February 20th, 2026

February 11, 2026

**Re: Mayfield-Tullamore Secondary Plan, Town of Caledon
Transportation Impact Study Update**

FIGURE 4 PROPOSED COLLECTOR ROAD NETWORK (AUGUST 2024 SUBMISSION)

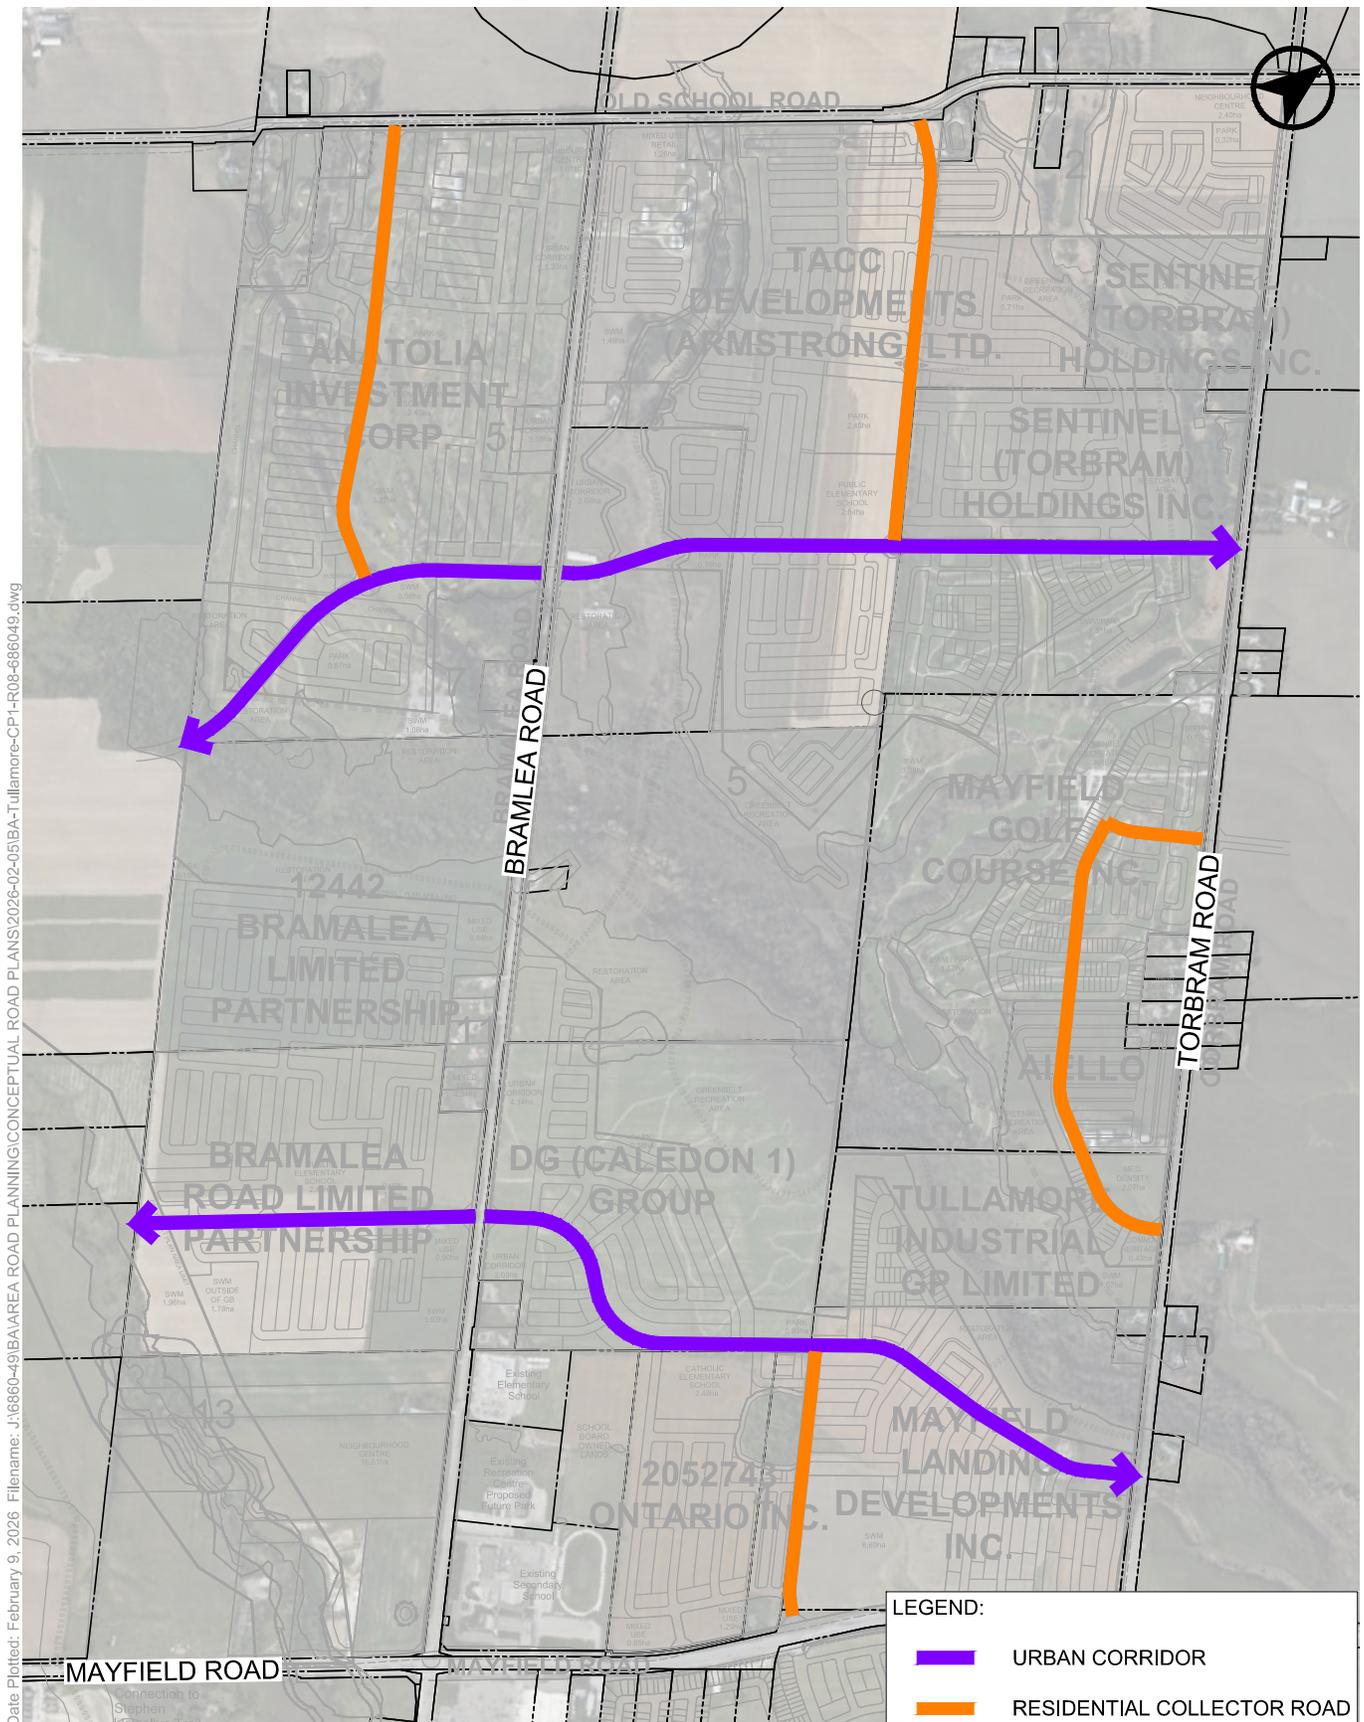
16. Figure 4 and Section 2.3 – Multiple roundabouts are proposed in the community at collector-to-collector intersections. Additional details for the roundabouts will be required at the Tertiary Plan and Draft Plan stage including preliminary design and ROW requirements. Note that Town Engineering Services may indicate that standard at grade intersections are preferred at certain locations in place of the proposed roundabouts.

Roundabout designs will be provided in the Tertiary Plan transportation study.

FIGURE 1 PROPOSED COLLECTOR ROAD NETWORK

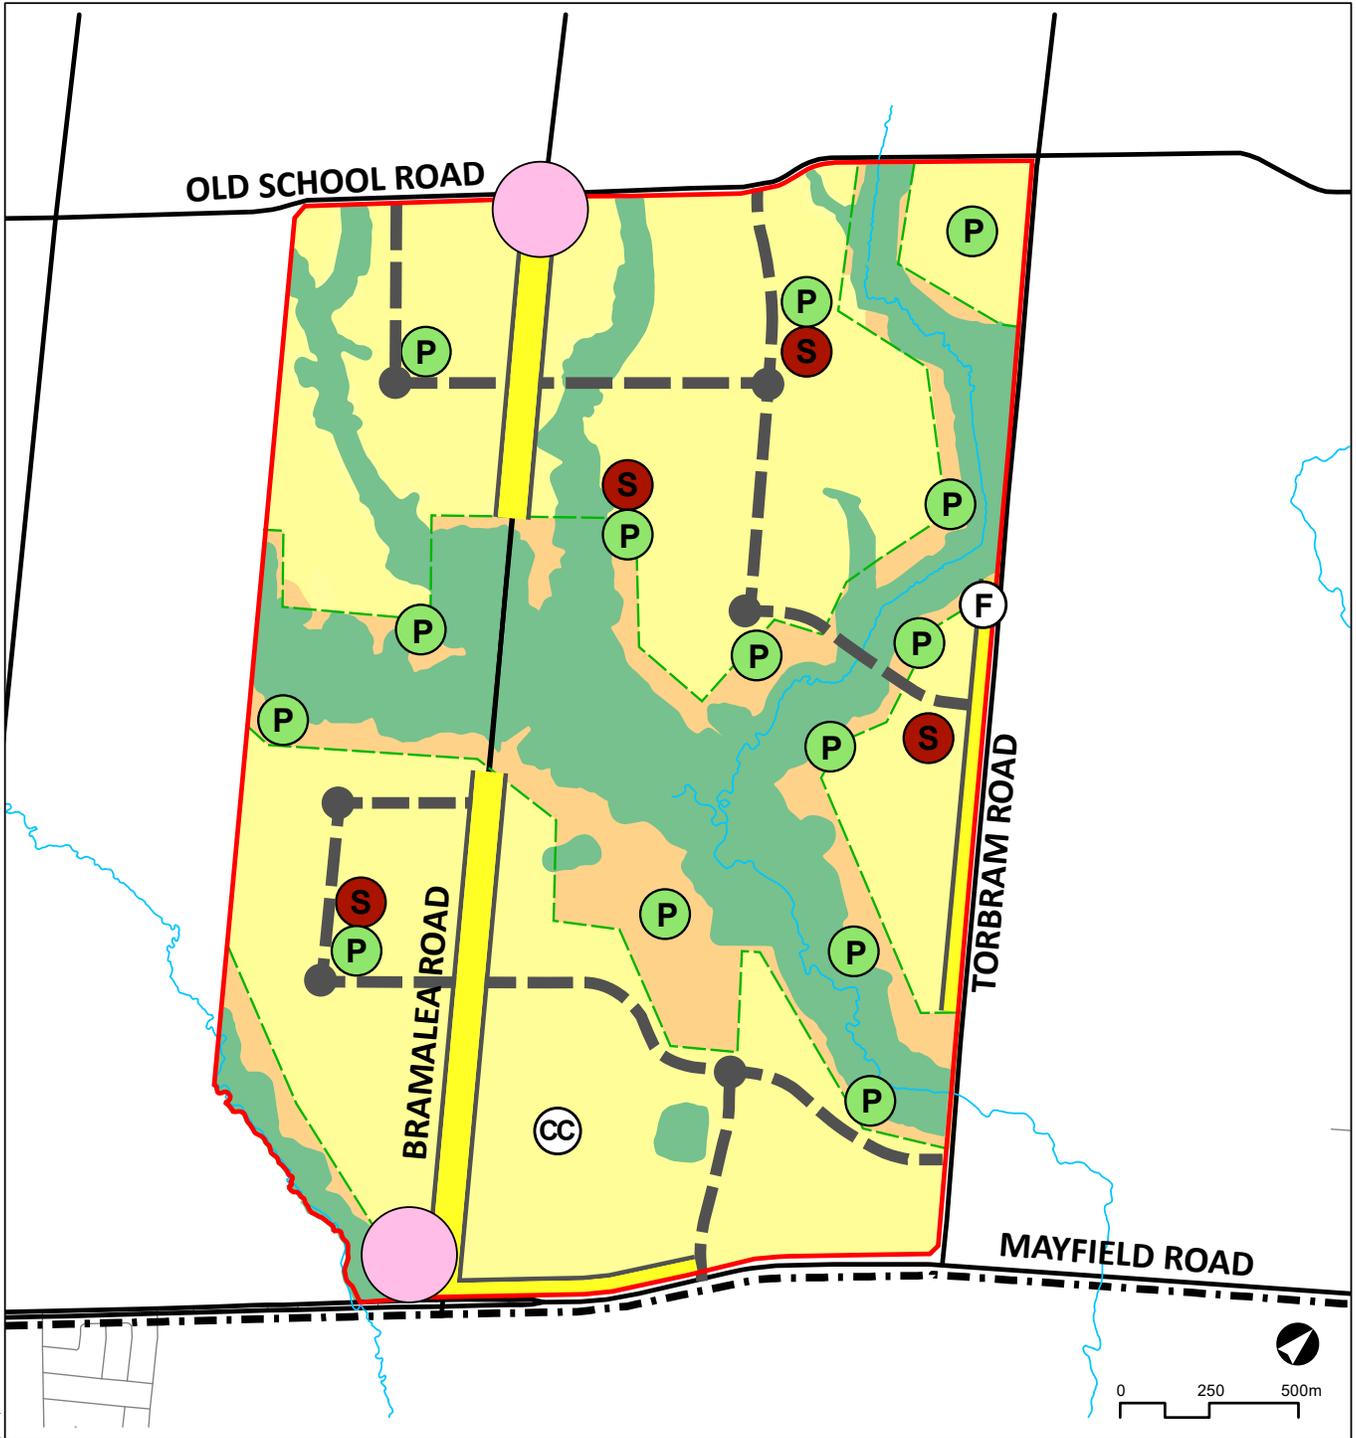
- Mid-Block East-West Collector:
A mid-block east-west collector road is required between Mayfield Road and Old School Road to provide essential connectivity between Dixie Road and Torbram Road. Current land use plans do not accommodate this connection.
Action: Revise the land use plan to incorporate the east-west collector road alignment

The land use plan has been revised to include two midblock east-west collector roads, as illustrated in **Figure 1**. The alignment of these collector roads is generally consistent with the Town's January 2026 MMTMP Addendum.
